LIGO-T1400223-v1

UIM Coil Driver modifications for larger range

P. Fritschel

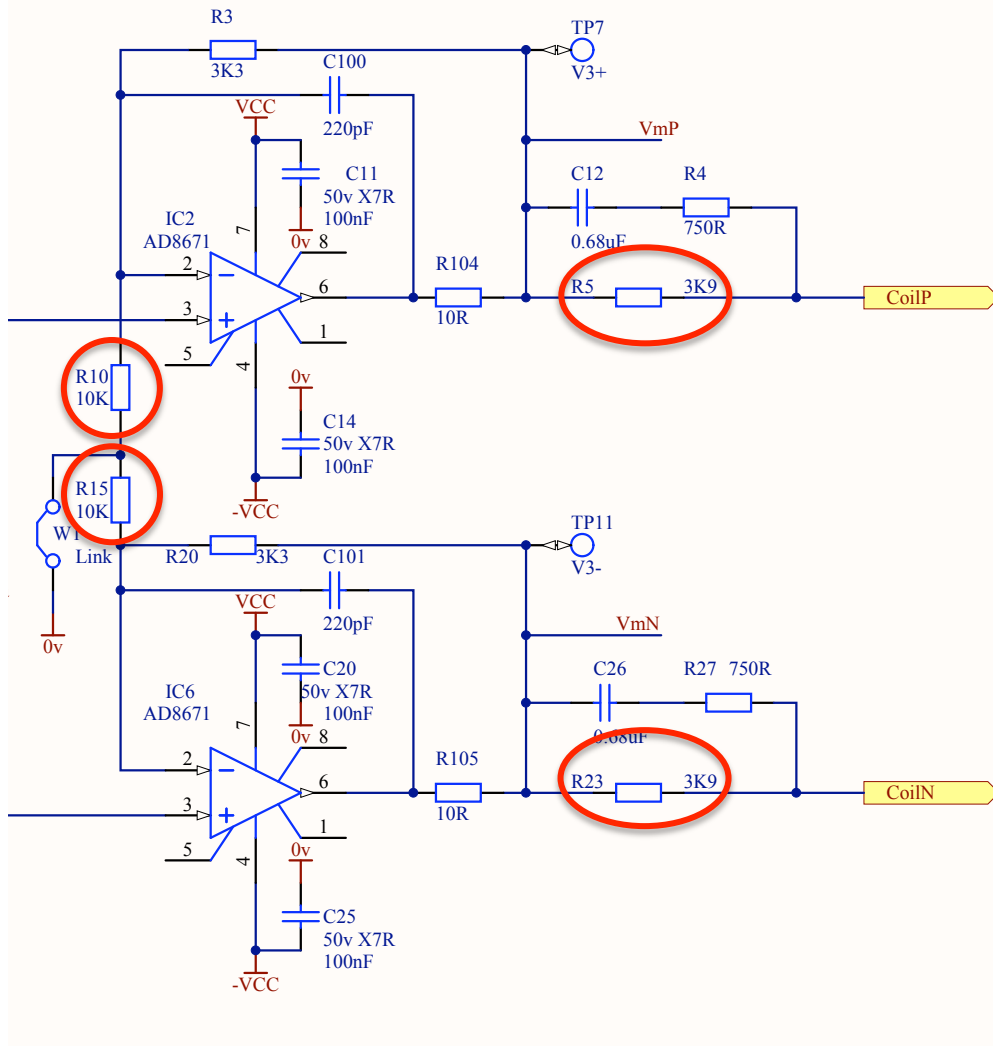
The UIM driver is D070481-v4. The modifications are in the differential output stages, as shown below.

Figure 1. Differential output stages of the UIM coil driver, D070481-v4. The resistors to be changes are circled in red. R10 & R15: change to 2200 ohms; this will make the voltage gain of these stages 2.5. R5 & R23: change to 2000 ohms. Maximum coil current will then be approximately 6.25 ma. The output drive current capability of the AD8671 is +/-20ma.

Figure 2. UIM coil driver response and output noise (input shorted). Red curves are for the modifications given in Figure 1.

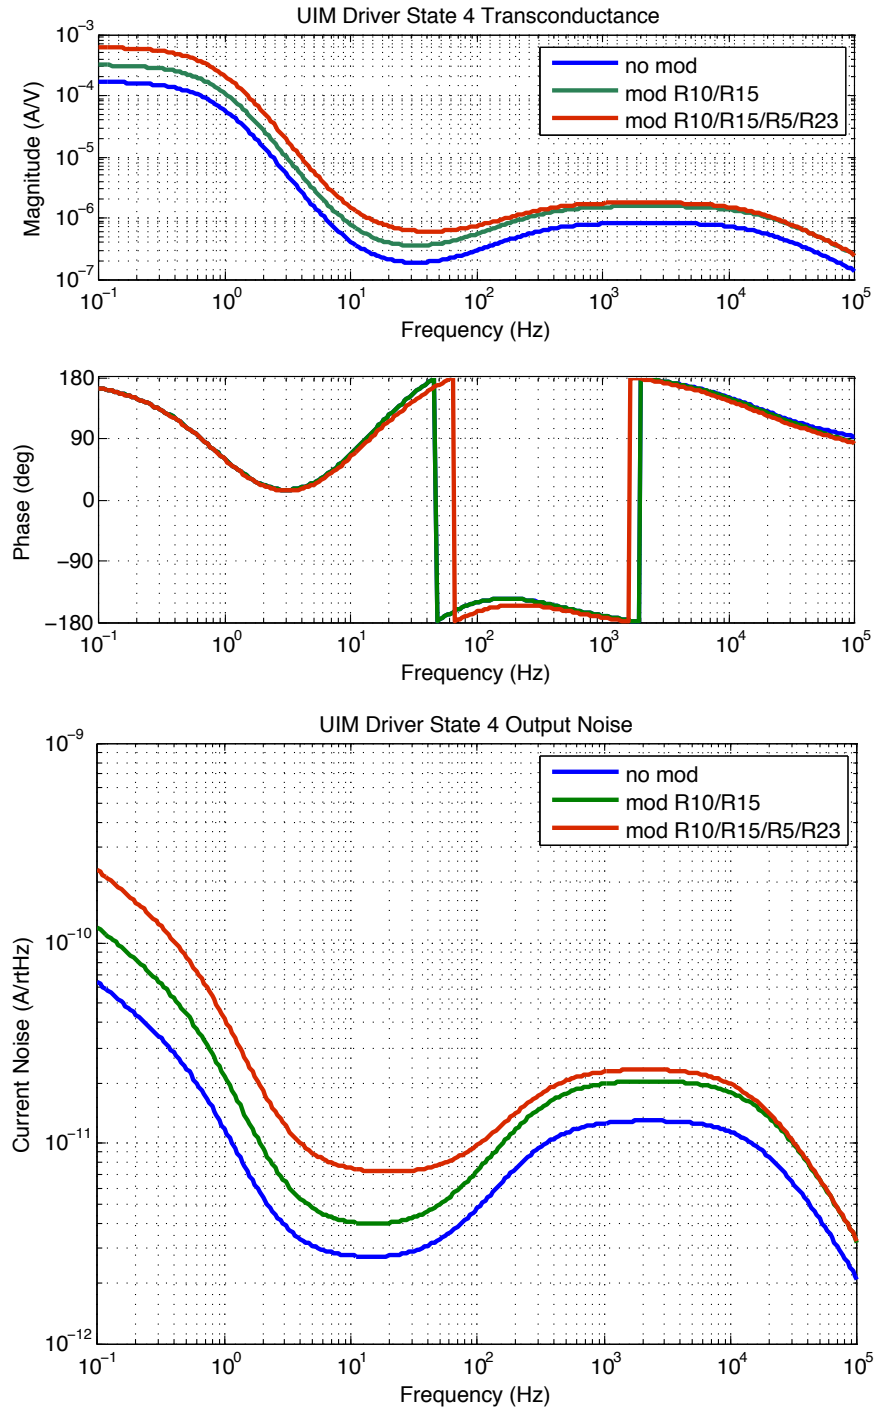
The output impedance network produces a zero/pole response that will change with the output resistor change. The zero moves from 50 Hz to 85 Hz. The pole stays at 312 Hz.

The total output current noise (not shown, but used in the next section) also includes DAC voltage noise at the driver input. However, with the typical DAC noise level of $150 \text{ nV/Hz}^{1/2}$, the DAC noise contribution is small (below $1 \text{ pA/Hz}^{1/2}$ at 10 Hz).

Figure 3. DARM displacement noise due to the ETM UIM coil drivers, as modified for greater range (blue curve). The black curve is the DARM displacement noise limit for technical noise sources, as given in the Systems Design, T010075.

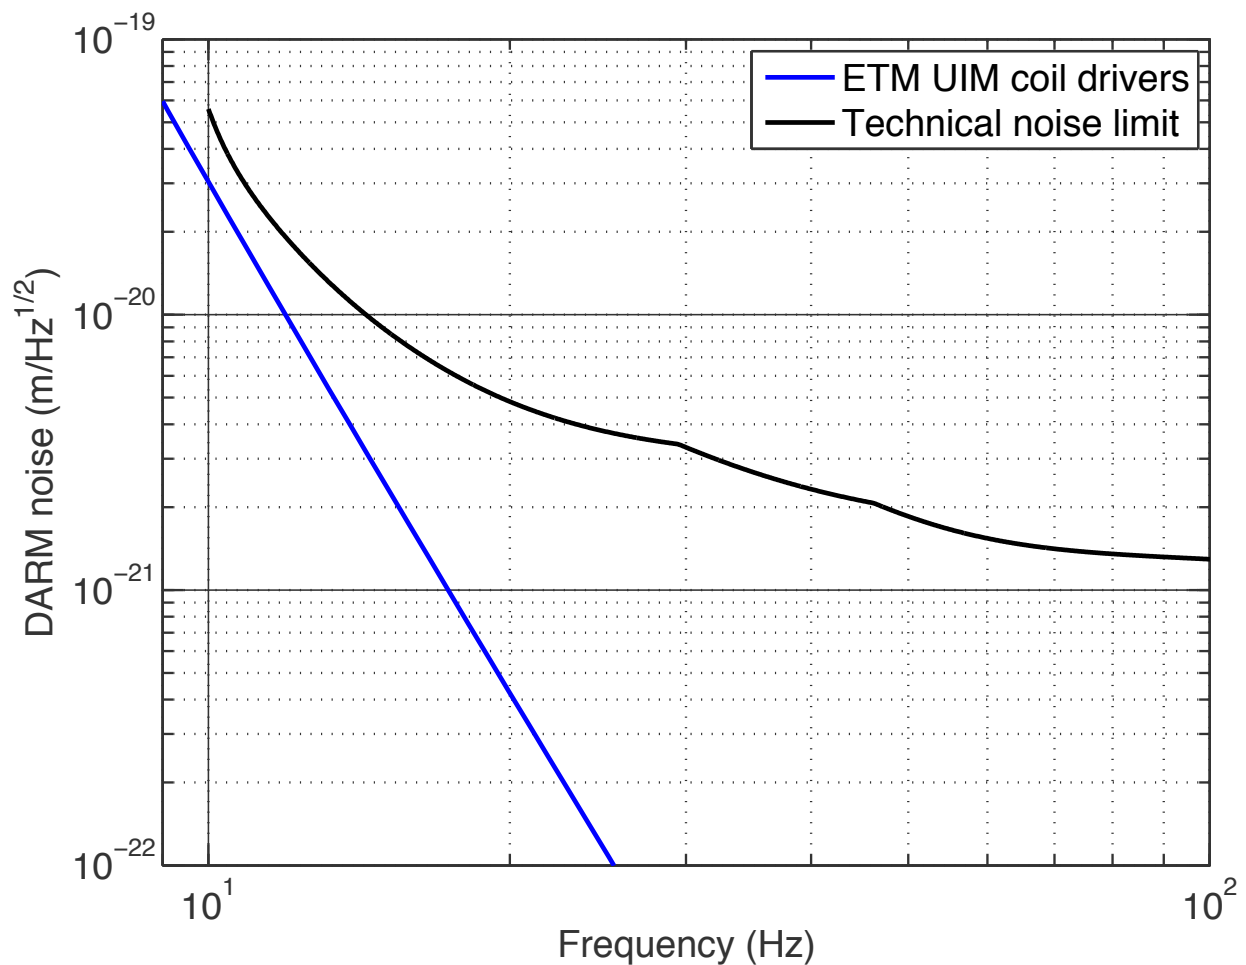
The interferometer displacement noise (DARM) due to the modified UIM drivers is calculated assuming the two ETM drivers are modified. Each UIM has 4 coil-magnet actuators, and the force coefficient of each actuator is 1.7 N/A . The resulting DARM noise is shown in the figure below, along with the technical noise limit.
